ALERT SERVICE BULLETIN

429-17-35

Revision A, 6 July 2021

SUBJECT: TAIL ROTOR BLADE 429-016-101-105,
INSPECTION OF.

Figure 1 - Possible Skin Crack Indication

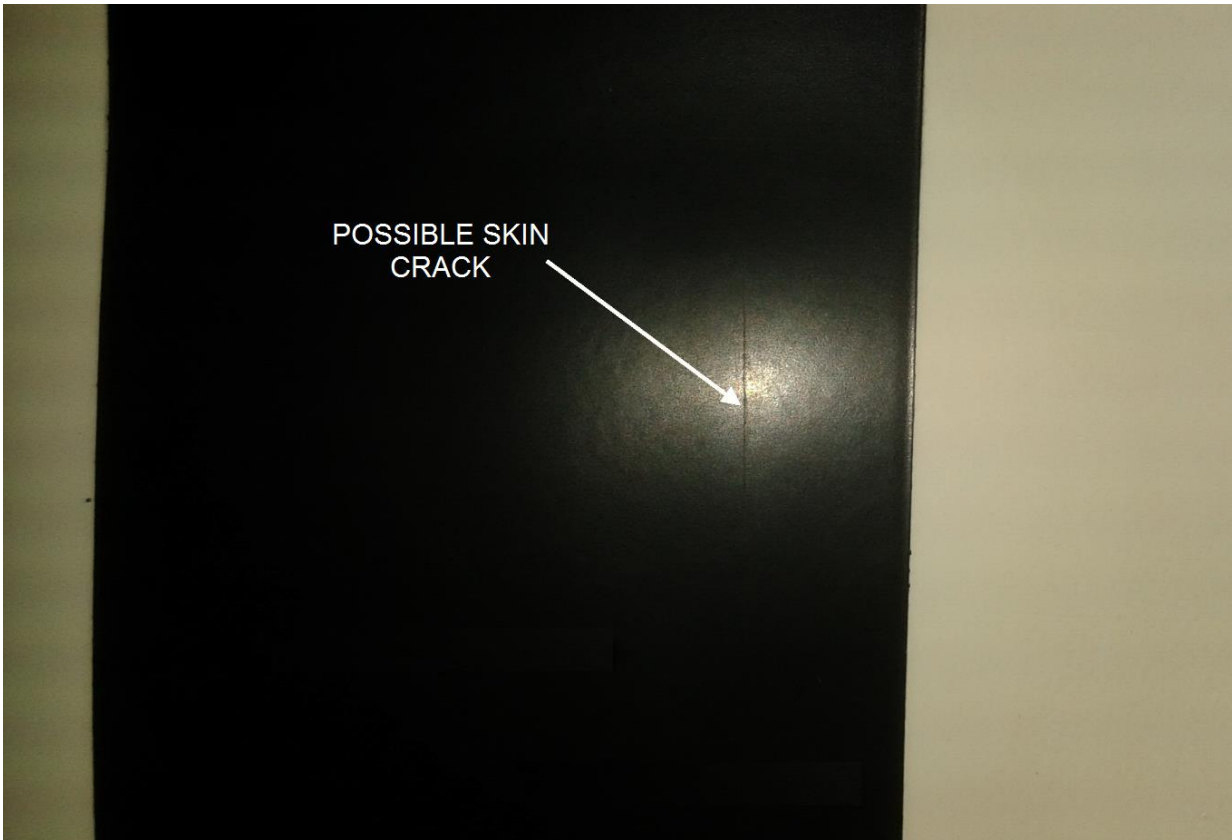
Bell Helicopter has received three reports of tail rotor blade skin cracks. As such this defect will become evident as a chordwise paint crack.

3. Carry out a general visual Inspection of all four tail rotor blade inboard and outboard skins for evidence of chordwise paint cracks.
4. Should a paint crack be detected in a tail rotor blade skin, please contact Product Support Engineering for further instructions.
5. Make an entry in the helicopter logbook and the Historical Service Record (HSR) indicating compliance with this Alert Service Bulletin.
